MIL-S-19500/495A(USAF)
AMENDMENT 3
21 June 1996
SUPERSEDING
AMENDMENT 2
25 April 1994

MILITARY SPECIFICATION

SEMICONDUCTOR DEVICE, UNITIZED, DUAL-TRANSISTOR, NPN, SILICON, TYPES 2N5793, 2N5794, AND 2N5794U, JANTX AND JANTXV

FIGURE 3. Physical Dimensions."

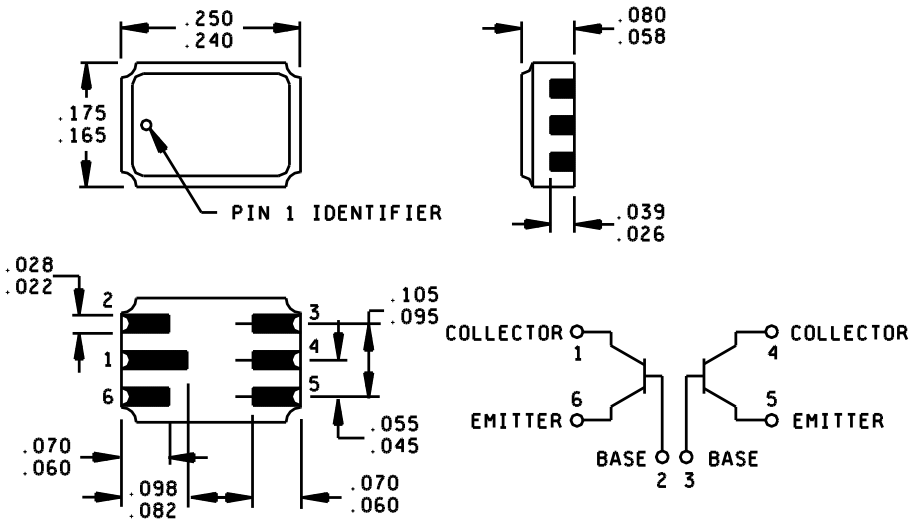
* FIGURE 3, delete and substitute as follows:

Inches	mm
.022	0.56
.026	0.66
.028	0.71
.039	0.99
.045	1.14
.055	1.40
.058	1.47
.060	1.52
.066	1.68
.070	1.78

Inches	mm
.080	2.03
.082	2.08
.095	2.41
.098	2.49
.105	2.67
.165	4.19
.175	4.44
.240	6.10
.250	6.35
